ADDENDUM NUMBER 3

February 11, 2025

**PROJECT: MONTGOMERY AIRPORT TERMINAL IMPROVEMENTS
FOR THE MONTGOMERY AIRPORT AUTHORITY
MONTGOMERY, ALABAMA
GMC PROJECT NO. TMGM250001 | AATL230031**

A0.01

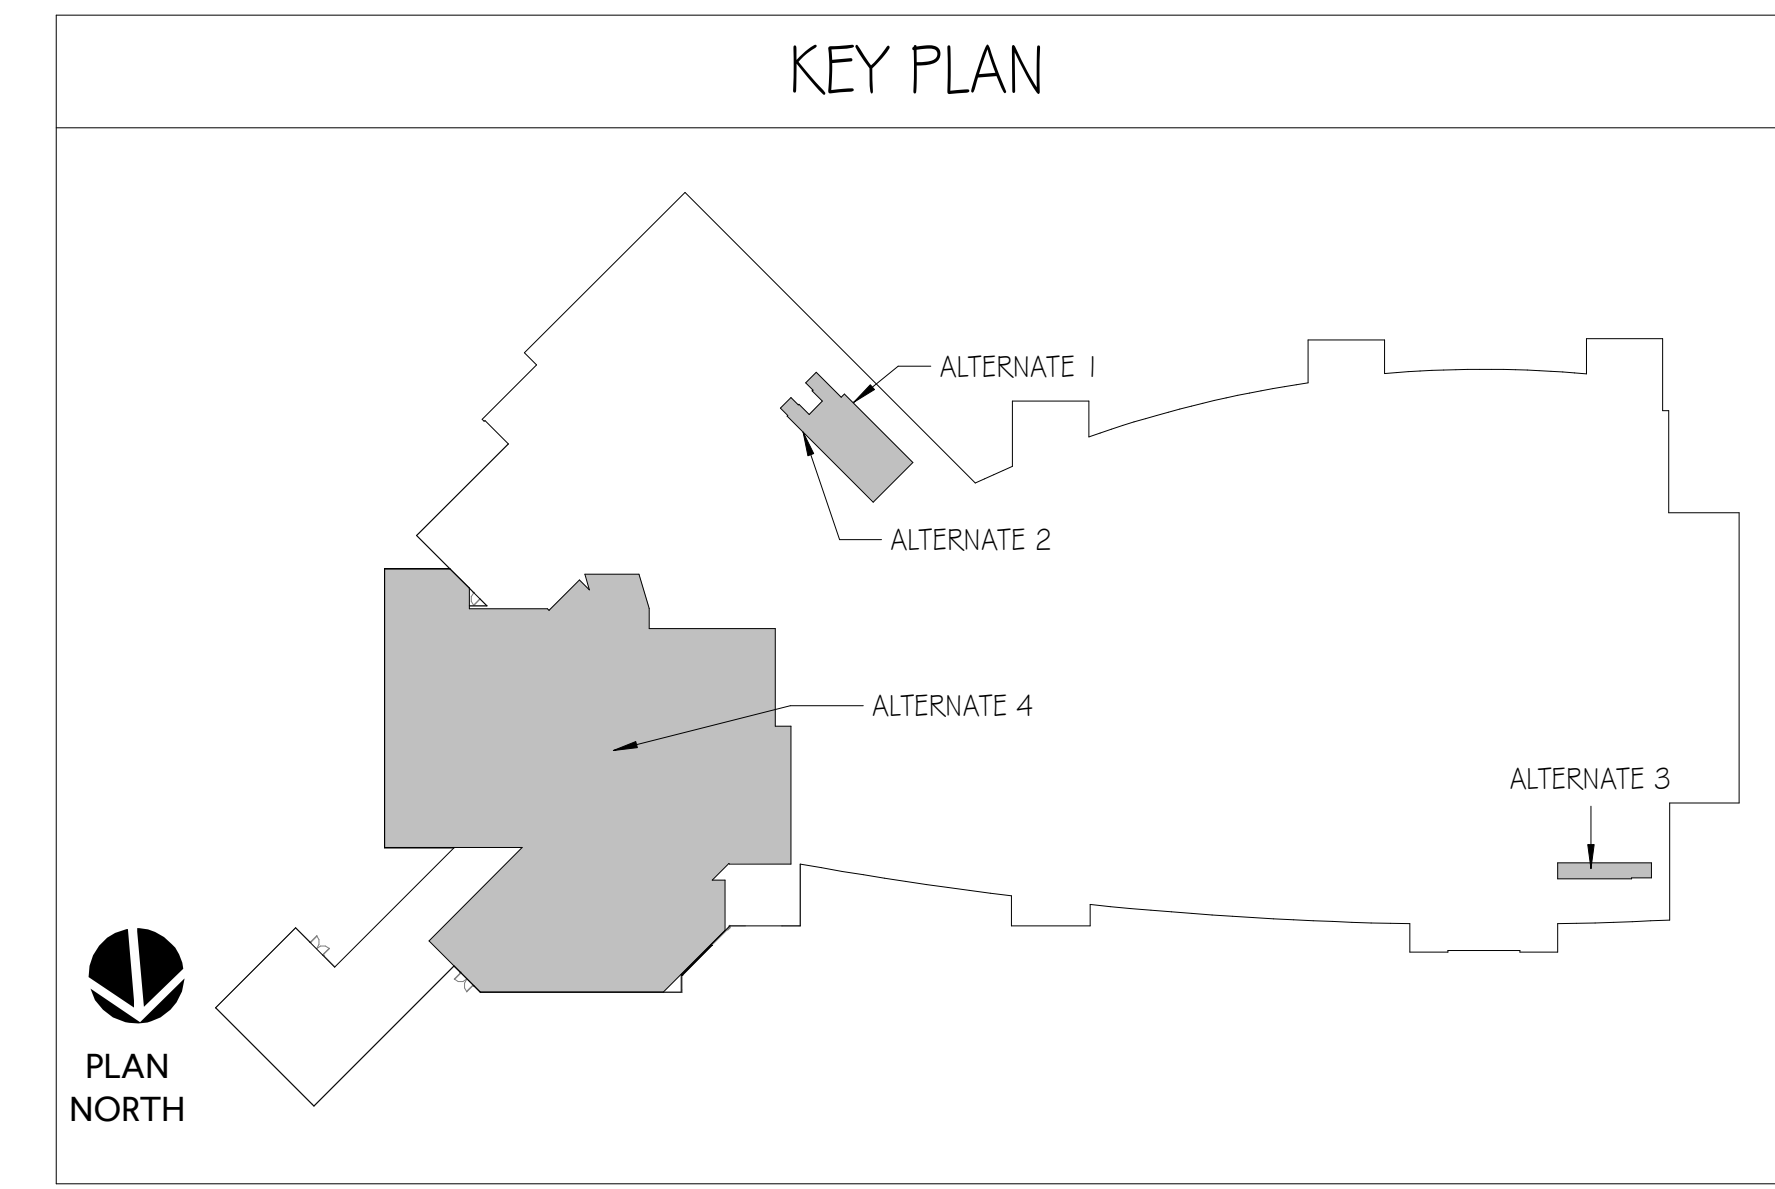
- A. Clarification: Key plan has been updated to be more accurate, and a notation regarding “floor patching” has been added to all demo drawings just to ensure that if any flooring is damaged during the demolition process it is to be patched and replaced to match existing.
- B. Delete Plan sheets A0.04, A0.05, and A8.02 in full entirety.
- C. See Attached Sheets: G1.01, G2.01, A0.01, A0.01, A0.03, A1.01, A1.012, A2.01, A2.02, A5.02 – Replace in their entirety from bid issued drawings.
